Environmental and Groundwater Issues and AGL's Hunter Coal Seam Gas Project

Final Report to Hunter Valley Protection Alliance

Dr Gavin M. Mudd

February 2010

Figure 2: Conceptual model of the aquifers and groundwater resources in the Broke (adapted from PB, 2009)

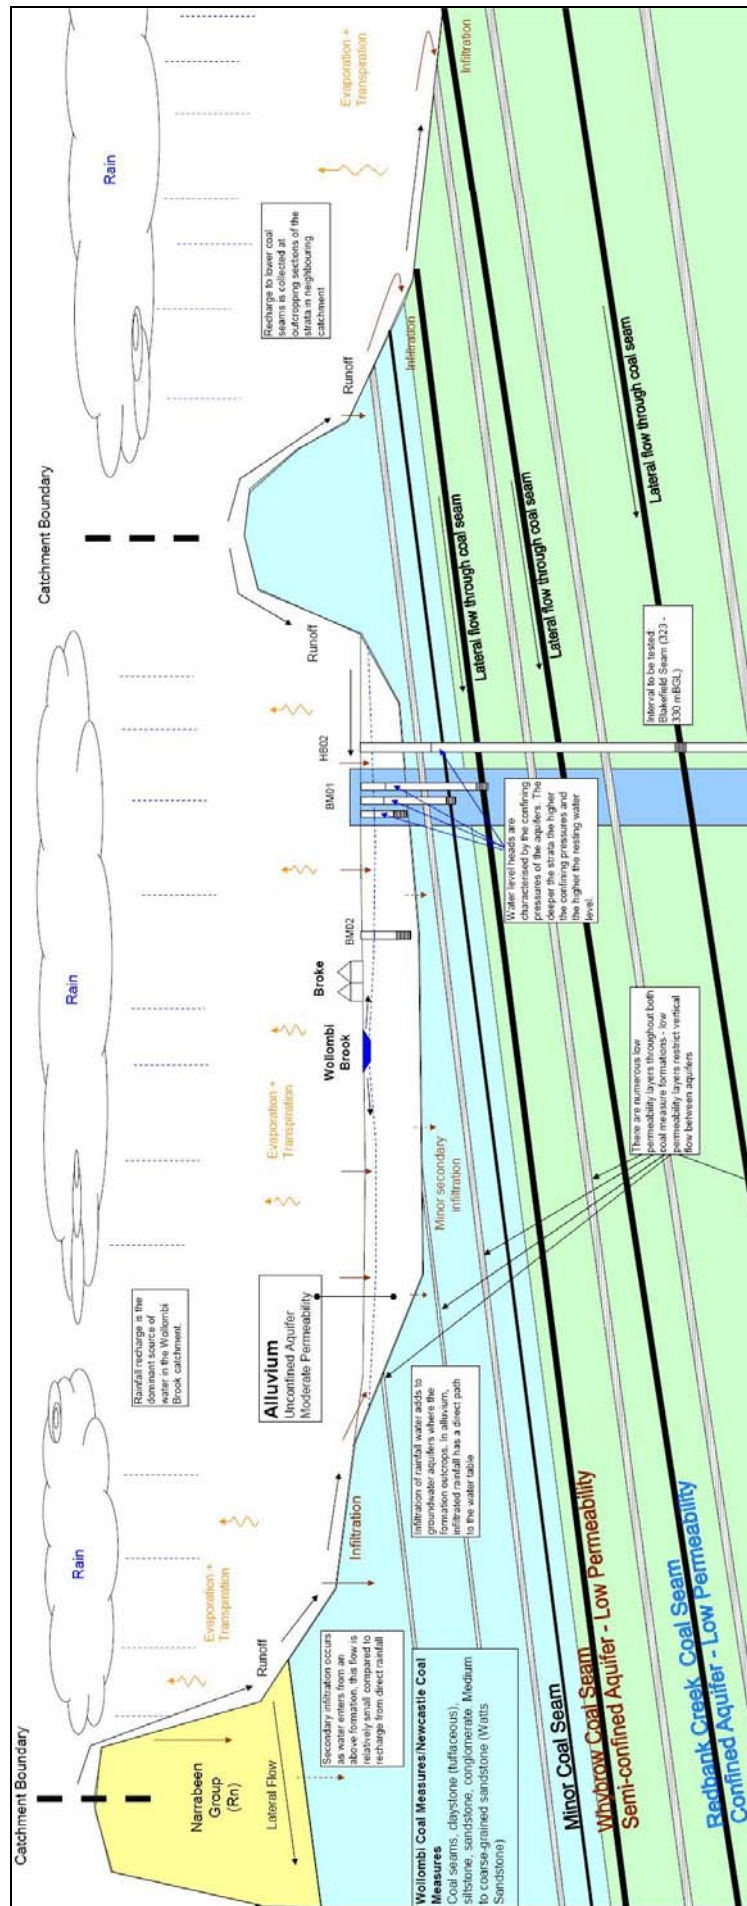
This conceptual representation of groundwater behaviour in the Broke area is fairly typical, and would be based on bore logs (showing different soil and rock types at different depths), experience from mining projects, water resources studies, monitoring data and theoretical considerations of groundwater flow in such rocks (eg. coal seams, alluvium). The movement of water between different parts of the environment, such as from runoff to soil infiltration and hence groundwater recharge, is often difficult to measure and monitor accurately. This leads to the necessity of making several assumptions about the systems' behaviour – the only remedy being long-term monitoring data. As new information becomes available, this conceptual model of the groundwater system can be updated and refined, but only if good data is continually obtained and used to inform the conceptual model.

- the frequency of monitoring is poor with respect to key and groundwater recharge processes (as shown in Figure 2), such as alluvial floods or climatic variability (eg. wet/dry conditions). For example, if the groundwater level increases or decreases in a given bore, is that due to recharge (increase), mine depressurisation (decrease) or dryer climatic conditions (decrease) ? Monitoring needs to be **at least monthly** on key bores to ensure a sufficient quality of data matching assumed groundwater flow, climatic or other processes (especially recharge rates);

Figure 5: Groundwater levels during the HB02 October 2009 pumping test, including an inset location map (adapted from Ross, 2009)

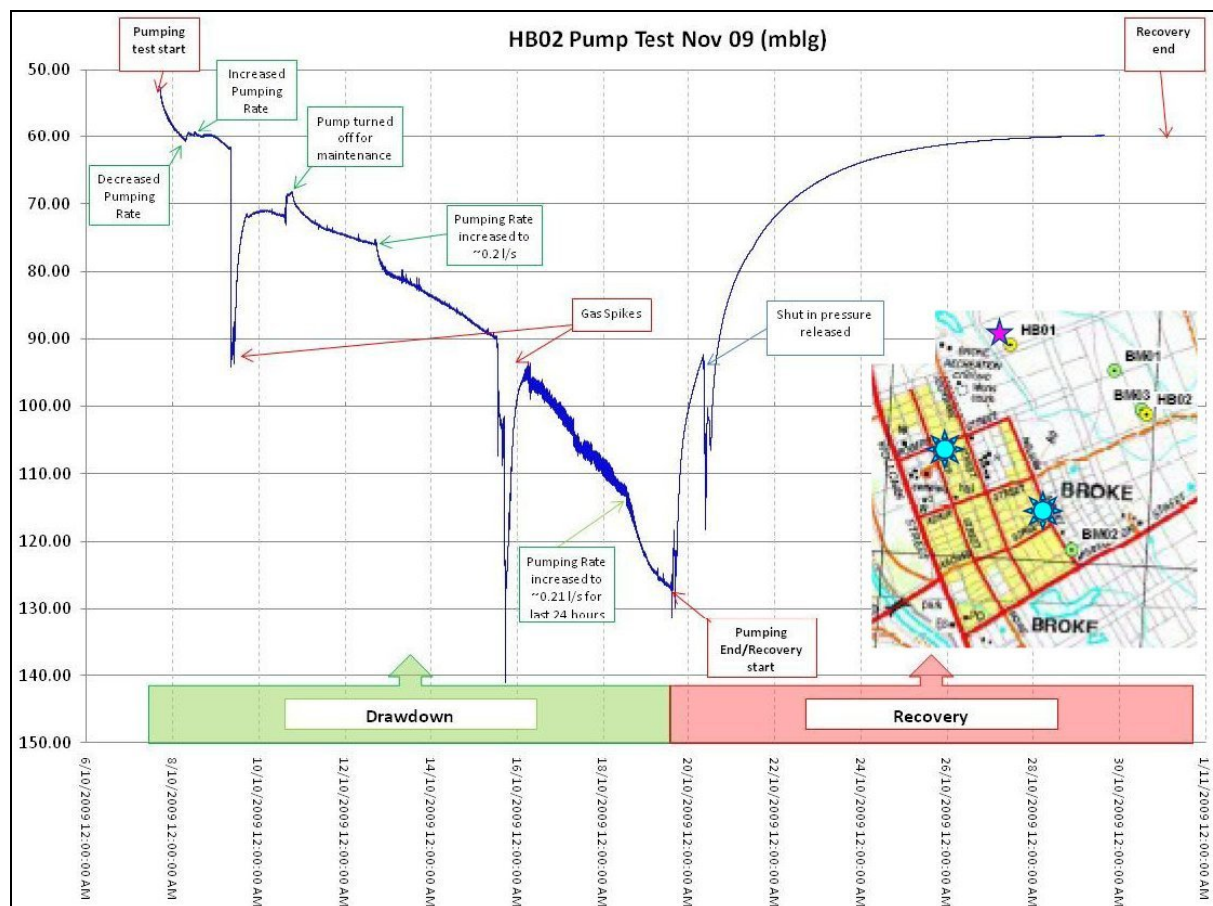
All groundwater levels are presented from the 'Top of Collar' (ToC), which is the top of the bore casing as it sticks out of the ground. Ideally, all results should be converted to relative levels, such as elevations with respect to the Australian Height Datum (AHD) – giving a precise view of the relative groundwater levels of each aquifer or layer independent of the height of each bore collar above ground. The results therefore need to be viewed carefully (especially since pumping bore groundwater levels are metres below ground; the difference should be small but it still needs to be accounted for). However, the results do suggest that at present, the groundwater levels in the alluvial aquifers associated with the Wollombi Brook are slightly higher (~1 m) than those in underlying aquifers and seams. The dry period in the latter months of 2009 was arguably beginning to have an effect on alluvial groundwater levels, since they were declining slightly by September.

The difference in groundwater levels suggests a minimal hydraulic gradient (ie. pressure difference) between the shallow and deeper aquifers, with a downward direction. This needs to be considered not just in a one-dimensional view of results at BM01, but with respect to the three-dimensional nature of the geology and hydrogeology. That is, it is important to understand the sources of groundwater levels – what are the locations and geologic features that control these pressures? Is it mostly a reflection of very low permeability barriers between shallow and deep aquifers? Or is this apparent downward gradient a result of the existing impacts from longwall mining which has led to minor head declines in deeper groundwater? It is not possible, on the extent of evidence available so far, to extrapolate the finding of a minimal hydraulic gradient without significant uncertainty. That is, although it is suggestive of minimal vertical groundwater flow, groundwater behaviour needs to be further investigated, understood and assessed in its full three-dimensional characteristics.

The remaining question is the degree to which the pumping test can be considered representative of any future extraction scenario. A major issue with any such extrapolation is that the test was only a single bore – compared to potential production scenarios which would require numerous bores. Further comment can be provided once the PB report is completed.
